RE: REVIEW OF SUNSET DEVELOPMENT SUBMITTAL

Subject: Sunset – Preliminary Plat

Subject: Sunset Preliminary Plat Submittal and Technical Review

**SUNSET
PRELIMINARY PLAT
SITE PLAN/PHASING PLAN**

TYPICAL SECTION - CRUSHER FINES LOCATED ON UPHILL SIDE

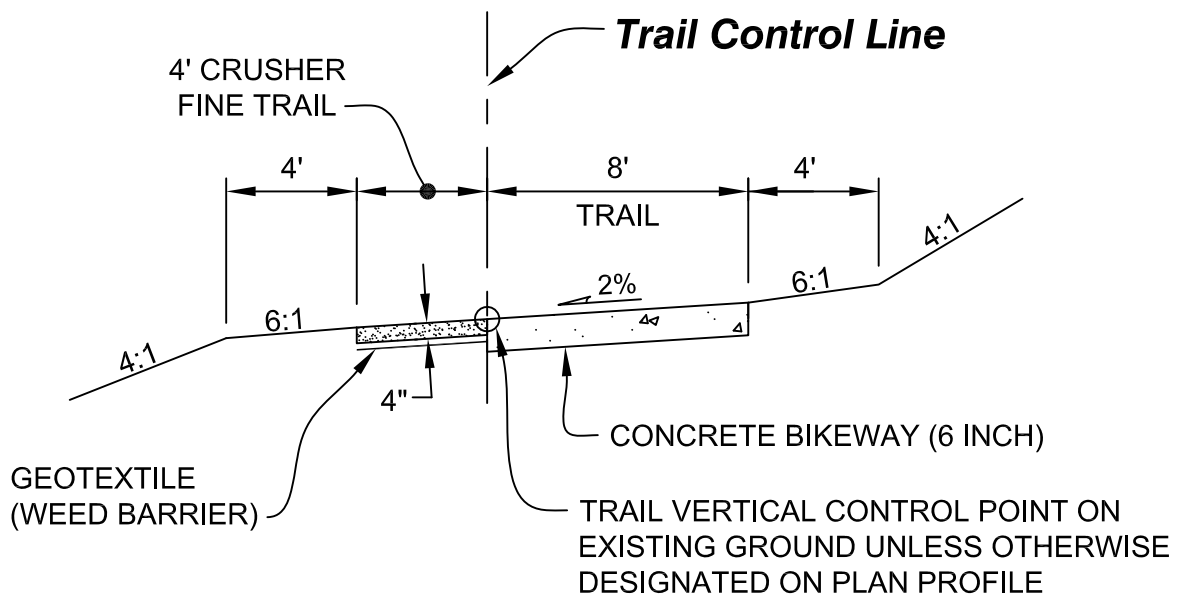
- Adjust grade adjacent to the spine trail that exceeds 4:1 in several areas. The grade adjacent to Street B appears to be very problematic.
- Crusher fines are located on the uphill side of the spine trail per Detail P25.

ENLARGED VIEW OF TYPICAL (TAPERED) FLARE FOR 8' MONOLITHIC CONCRETE TRAIL

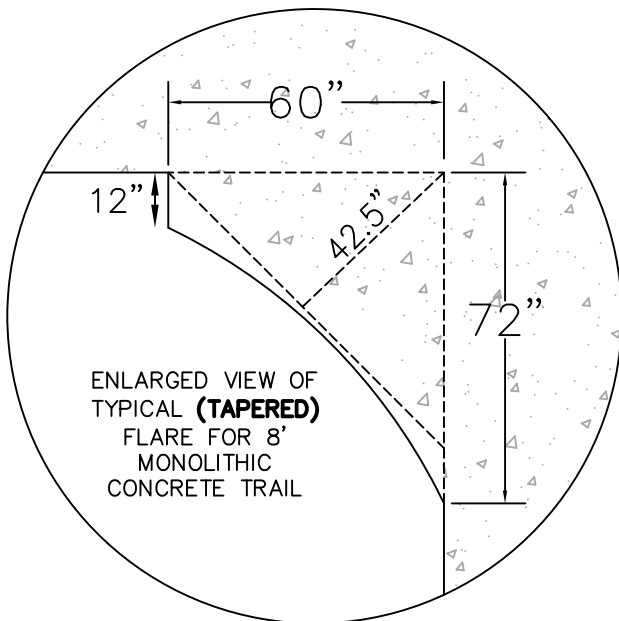
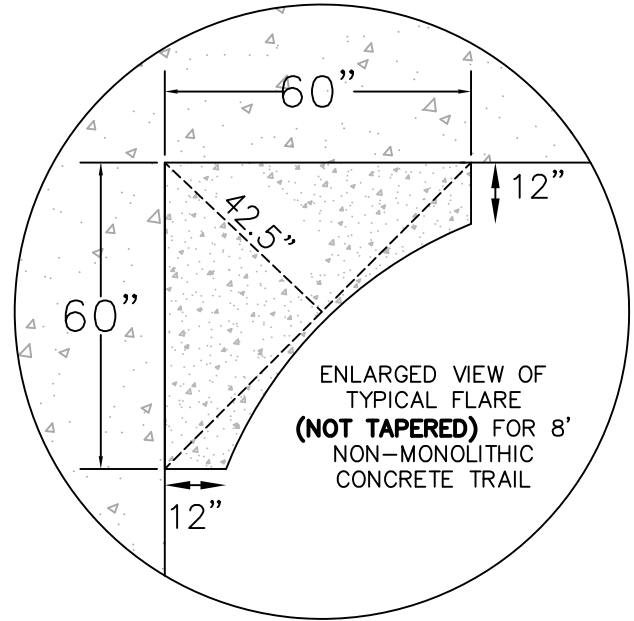
- Minimum side clearance shall be 8 ft. from the edge of spine trail; ditches must remain out of this area.
- At each spine trail intersection, there shall be a flared end to assist maintenance vehicles, pedestrians and cyclists in navigating the turn. At ninety (90) degree intersections, flare shall be placed. For more information, refer to Detail P27 for required flare sizes. Please use the “Monolithic Trail Connection” design for the local trail connections that connect to the spine trail.

T1	1	TITLE SHEET
SP1	2	SITE PLAN/PHASING
SP2-SP7	3-8	SITE PLAN
TY1	9	TYPICAL SECTIONS
EC1	10	EXISTING CONDITIONS
GR1-GR3	11-13	GRADING PLANS
OU1	14	OFF-SITE UTILITY PLAN
OU2-OU3	15-16	OVERALL UTILITY PLAN
16 TOTAL SHEETS

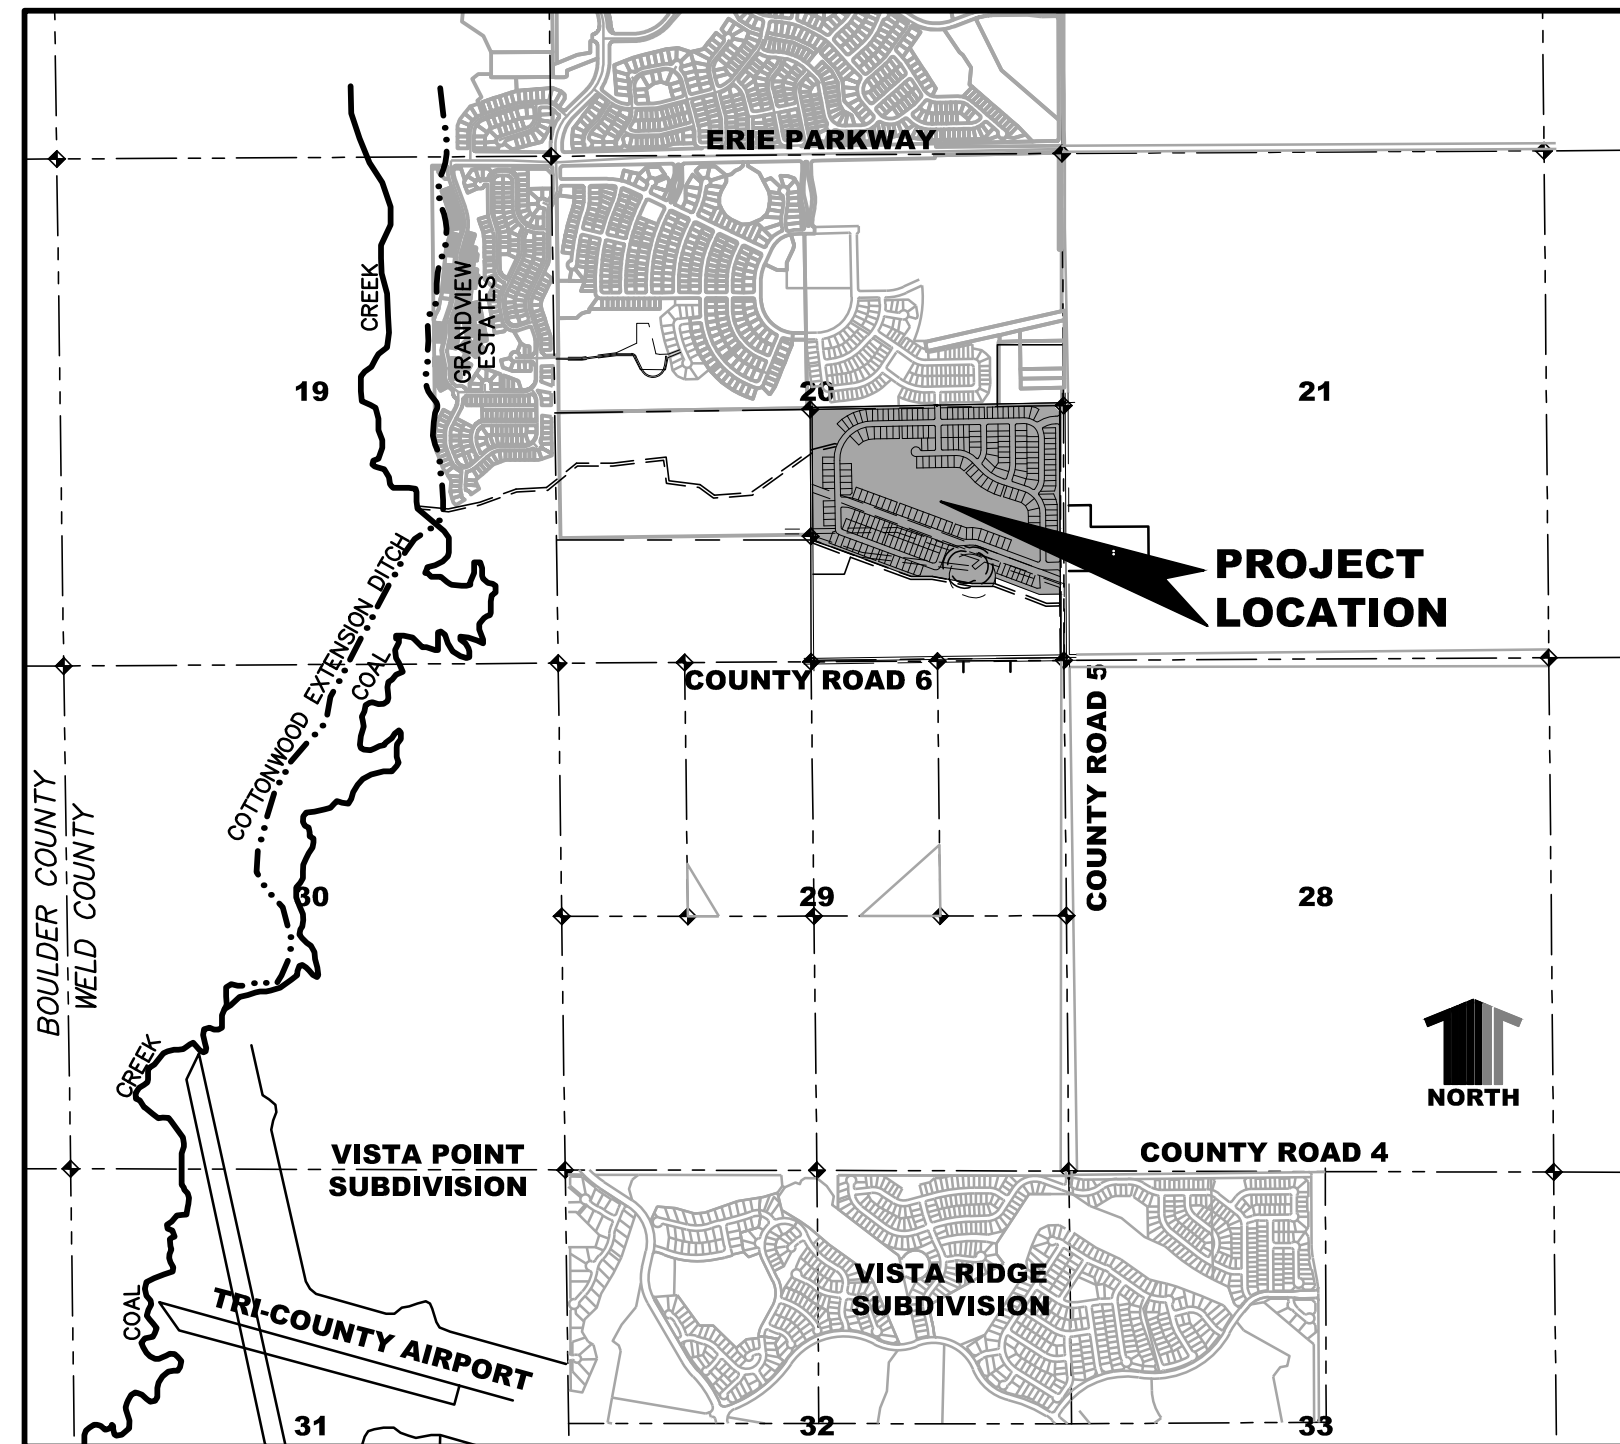
- a) *On Sheet T1, there is a section in the first column called Housing Diversity and under that it shows two lot sizes. These lot sizes do not reflect the single family detached variations found in the UDC. The single family detached variations that exist as are described in the UDC are Lot Sizes of 5,000 to 9,999 sq. ft. and Lot Sizes 10,000 to 39,999. Could you have this chart updated to reflect the UDC housing types and update all the columns to reflect this?*

- a. Landscape Plan
 - 1. Pocket Park details shall receive final review at final plat.
- b. Sheet T1 – Title Sheet
 - 1. Update the Land Summary Chart to reflect the correct housing diversity information so that it reflects the types and variations per the UDC as defined in 10.6.7.
- c. Sheet OU1 - Off site Utility Plan
 - 1. Off-site easements for sewer and stormwater are necessary.
- d. Sheet OU2 and OU3 – Overall Utility Plan
 - 1. Rear yard drains shall be put in a tract owned and maintained by the HOA or Metro District.
 - 2. The Drainage Report has been updated and Merrick has provided comments dated May 5, 2019.
 - 3. Merrick notes that “flow outfalls from a storm sewer pipe to a natural area” in a number of areas which could cause erosion. This could result in off site impacts (on Town Open Space and private property) and impacts within the proposed open space.

Please update the Land Summary chart on Sheet T1 under residential uses to reflect the two lot sizes that are proposed: lot size 5,000 to 9, 999 sq. ft. and lot size 10,000 to 39, 999 sq. ft.
